INDIANA UTILITY REGULATORY COMMISSION

**APPLICATION OF PLEASANTVIEW)
UTILITIES, INC. FOR A NEW SCHEDULE)
OF RATES AND CHARGES FOR) CAUSE NO. 46122-U
WASTEWATER SERVICE)**

TESTIMONY OF JAMES T. PARKS

THE INDIANA OFFICE OF UTILITY CONSUMER COUNSELOR

Figure 1 – Wastewater Flows compared to Water Sold, and I&I (gallons per day)

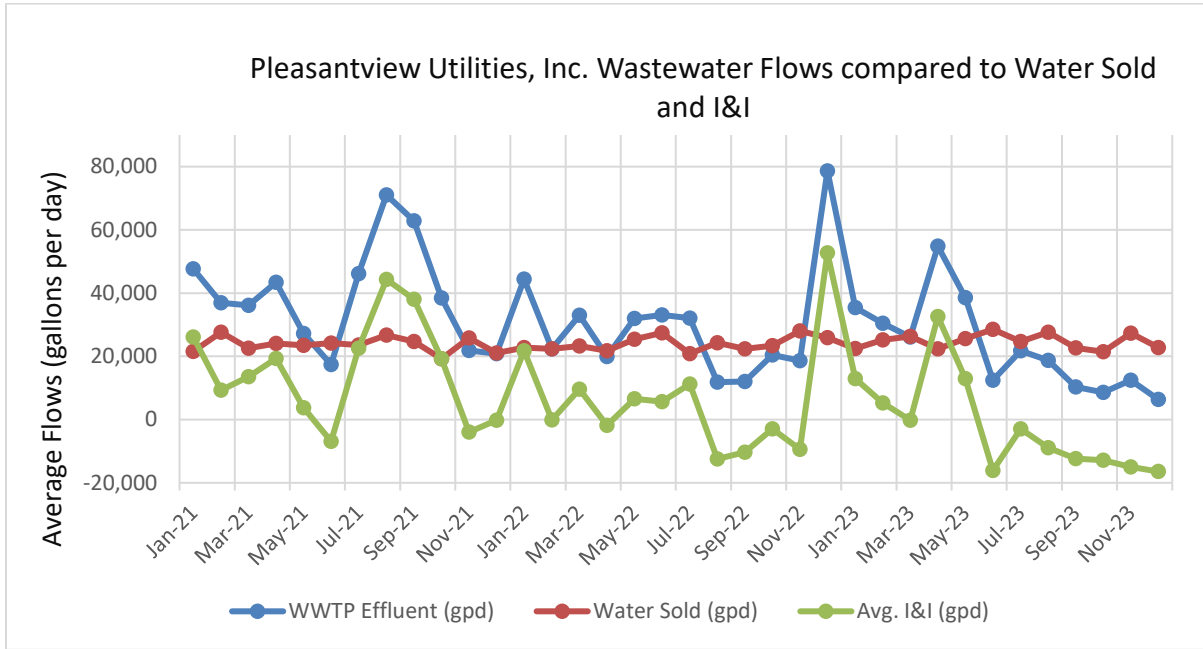
1 Applicant's monthly treated effluent flow data reported to IDEM for years 2021 - 2023
2 and compared it to Applicant's reported water purchased and water sold data by month
3 for those years. I then calculated the amount of I&I from the collection system, which
4 I show graphically in Figure 1 and tabulated in OUCC Attachment JTP-11.

6 **A:** Yes. WWTP capacity is 60,000 gpd but flows regularly exceed this capacity during wet
7 weather events.³⁷ In Cause No. 44351-U in 2013, Applicant's engineer reported a peak
8 day flow of 325,000 gpd which is over five times the plant's 60,000 gpd rated
9 capacity.³⁸ More recent data in the last four years still shows high peak flows up to
10 277,000 gpd. Table 1 shows my tabulation of 2021 to 2024 flow metrics from data
